RE: Blythe Solar Power Project, Docket No. 09-AFC-6
Responses to January 15 and 20, 2010 CEC Email Query from CEC staff, Additional Information regarding
Transmission System Engineering.

**Responses to CEC Email Requests,
January 15, 2010
Transmission System Engineering**

Blythe Solar Power Project

Data Response Queries – January 15, 2010

BLYTHE CENTRAL 230KV SWITCHYARD

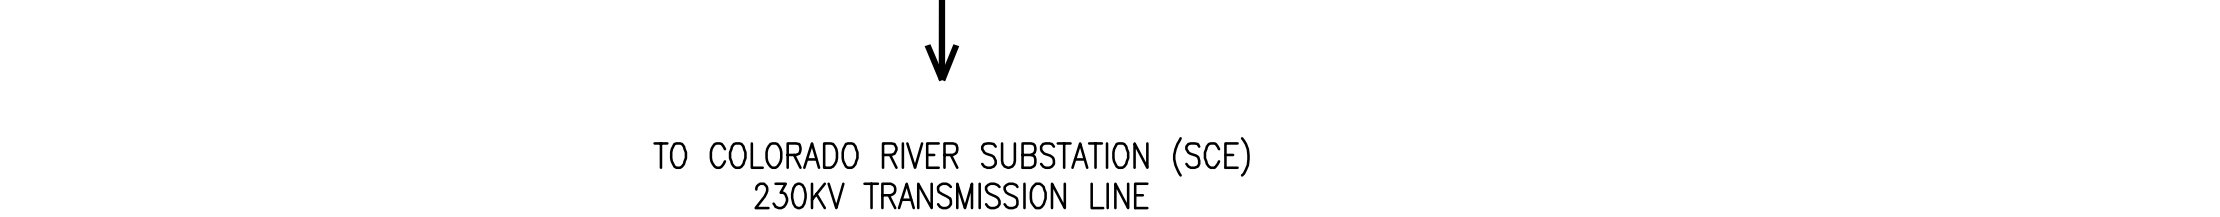
1) Clarify the proposed voltage and step up voltages.

4) Update Figure 2-9 (one-line for the generators and gen-tie), Figure 2-14 (pole), and Figure 2-15 (Colorado River Substation connection). Figure 2-15 needs to show step-up transformer connection and transformer data.

The T-line voltage has been previously provided on Figure 2-9. Additional voltage information is identified on Figures 2-14, 2-15, and 2-15a which are provided as attachments to this submittal. The step-up voltages are provided on Figures 2-8, 2-9, and 2-15a also provided as an attachment to this submittal.

Figure 2-9 was previously provided as stated above. Figure 2-14 is being provided. Applicant's Figure 2-15, Colorado River Substation SLD, is limited to Palo Verde I, LLC's scope of supply. SCE 230kV/500kV step-up transformer connection and transformer information is provided, however, on Figure 2-15a.

Figure 2-14

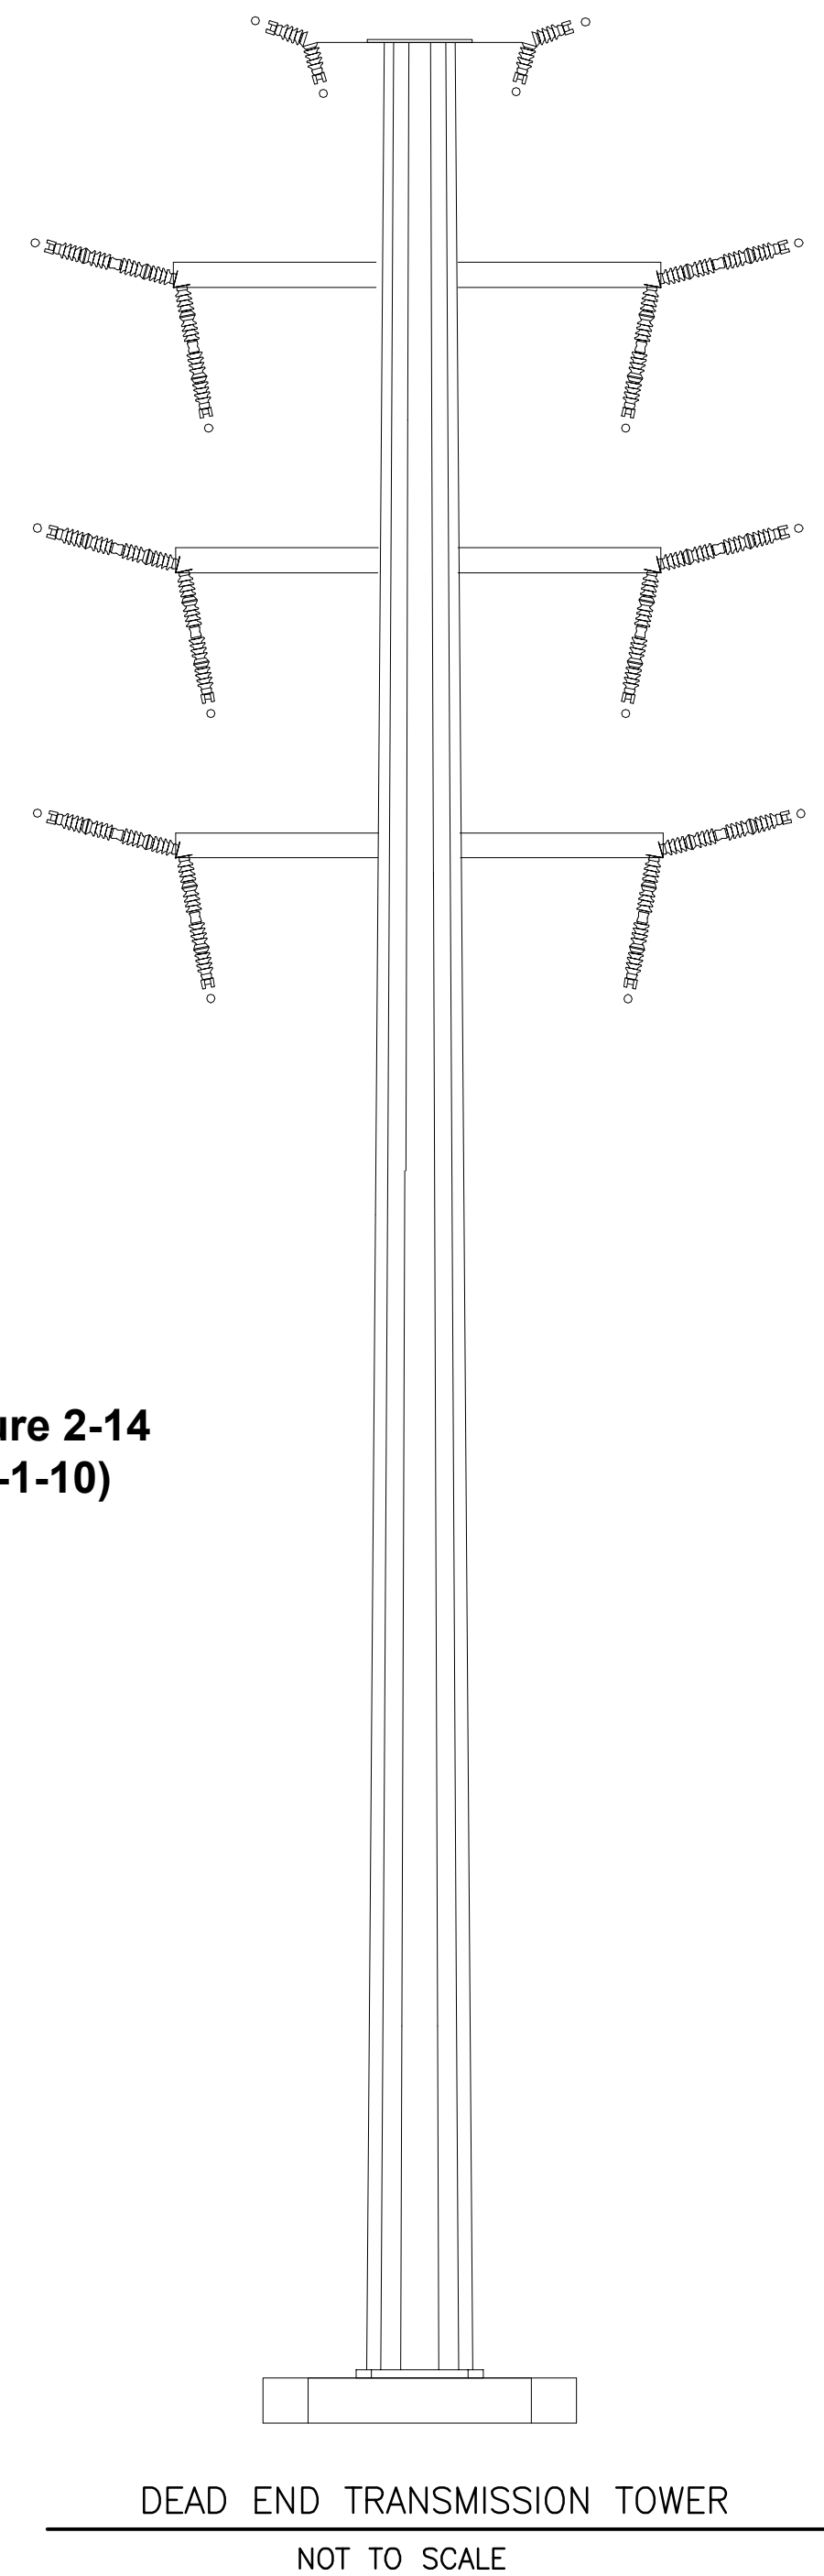
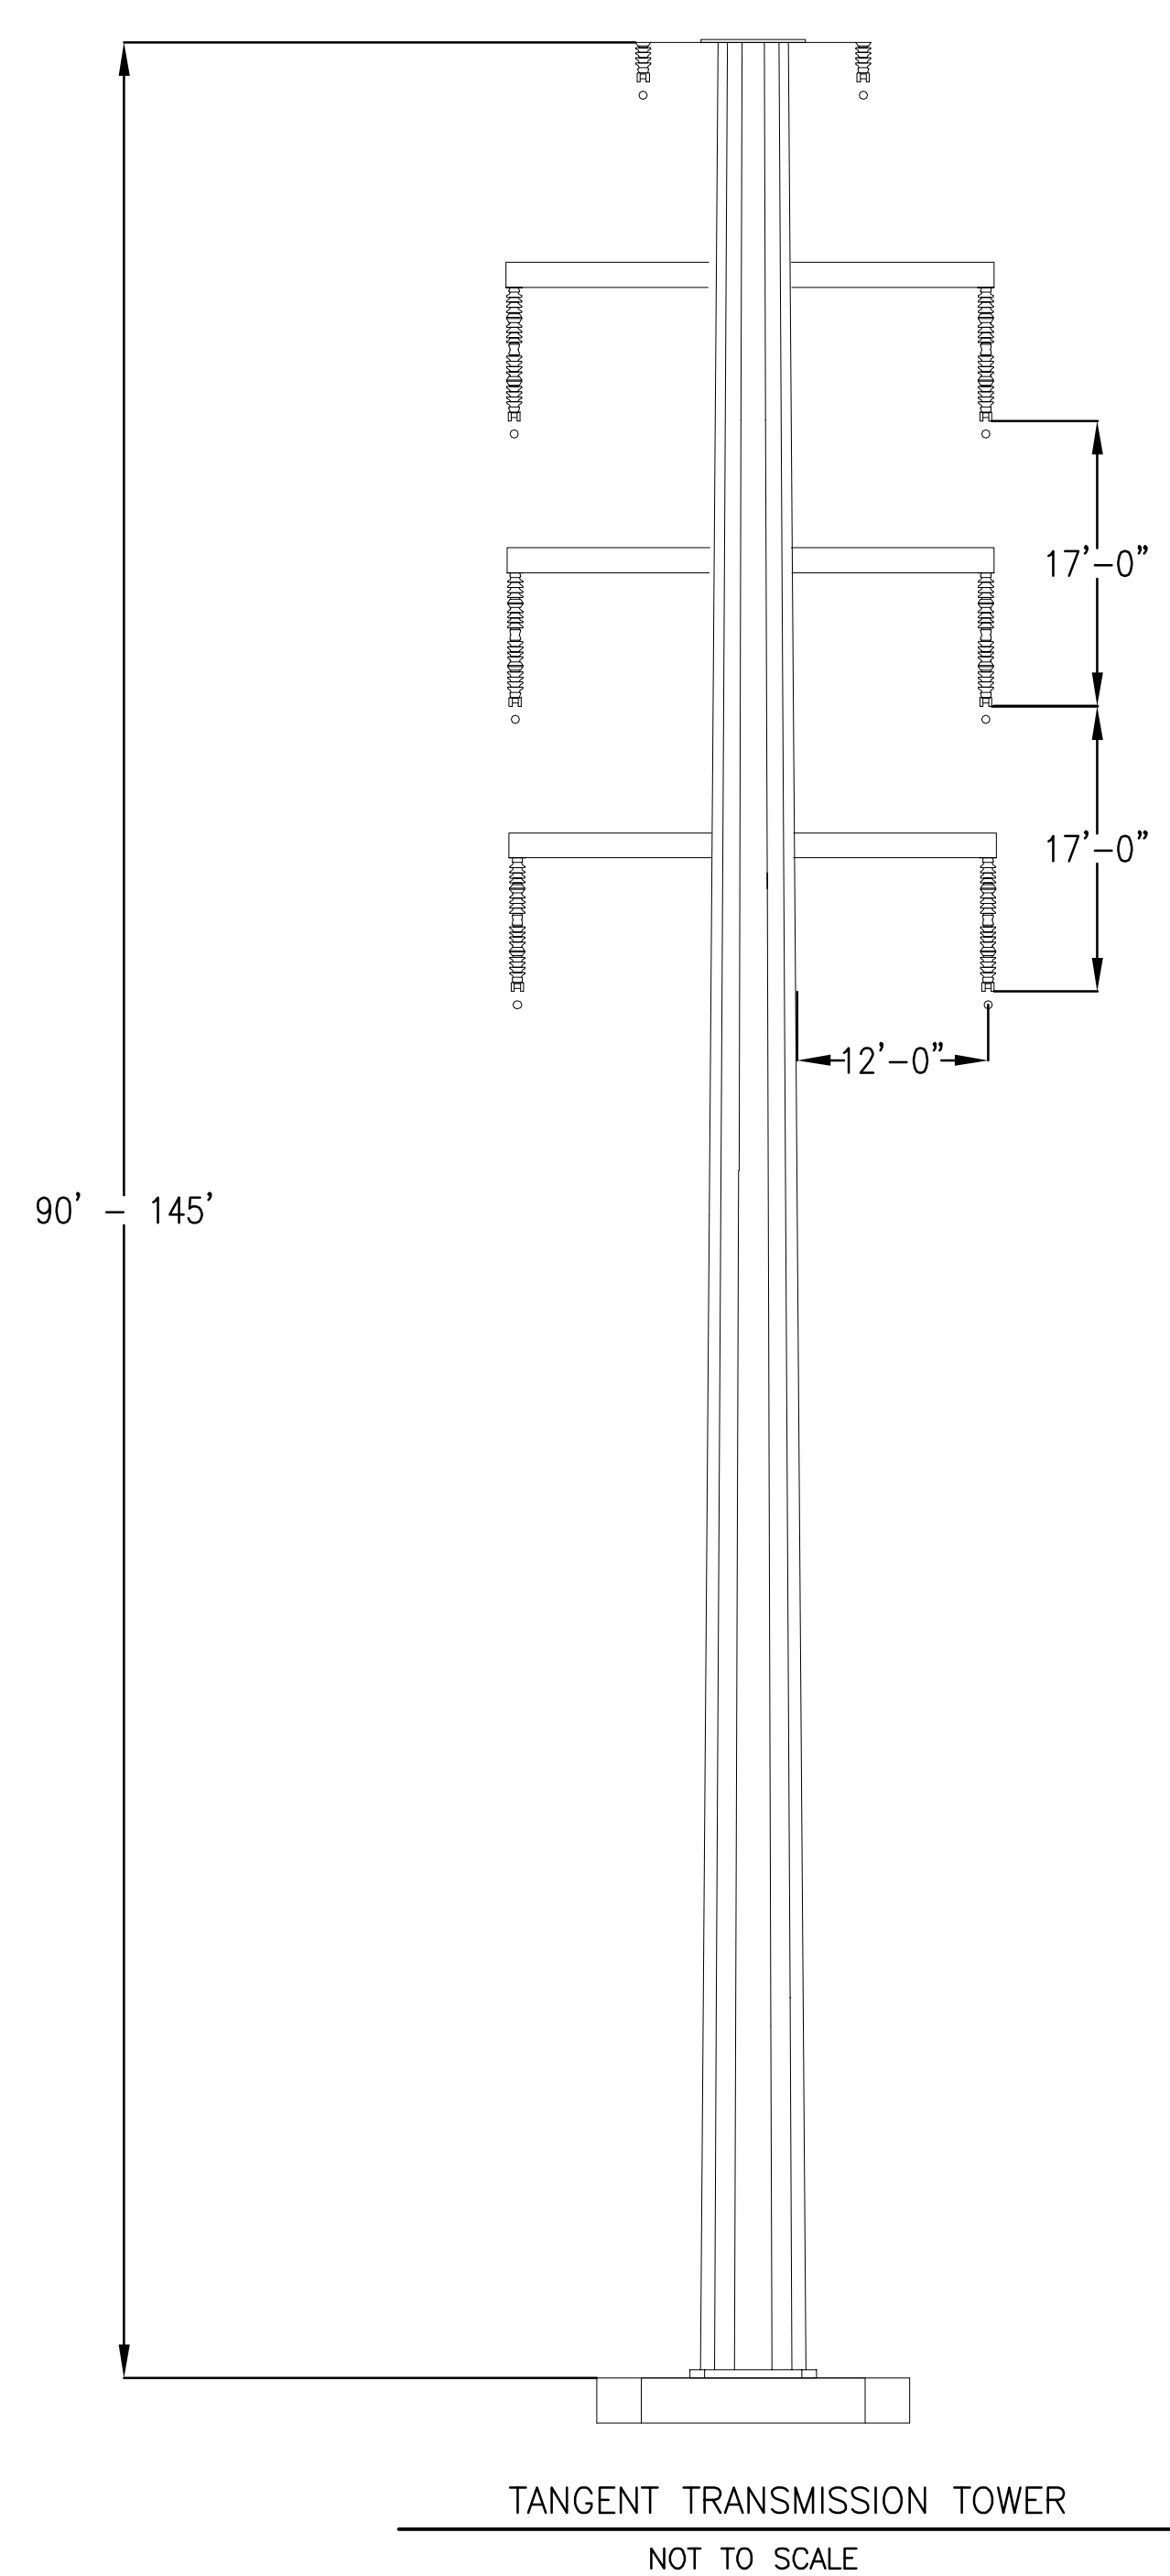
3) Update pole structures: take-off, dead-end, pole type, and height information.

The updated pole structure information inclusive of take-off, dead end, pole type and height is provided on Figure 2-14.

Figure 2-15a

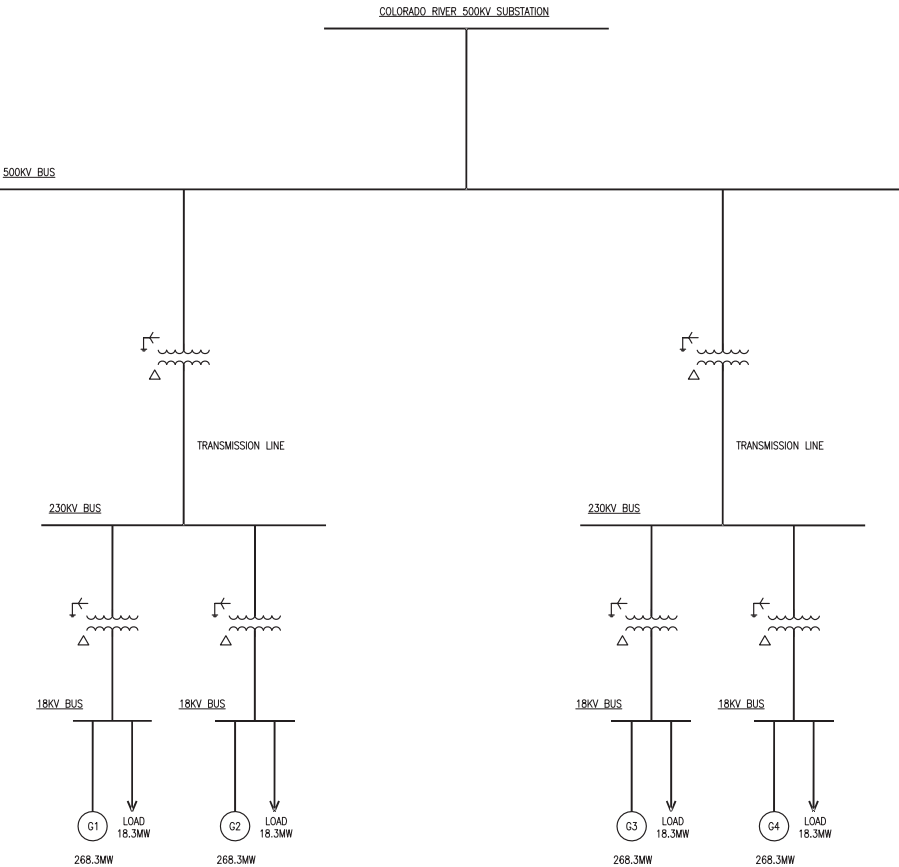
2) Provide gen-tie information: number of conductors, type, rating, and length.

The number and types of conductors are provided on Figures 2-14, 2-15, and 2-15a, with the rating and length given on Figure 2-15a.
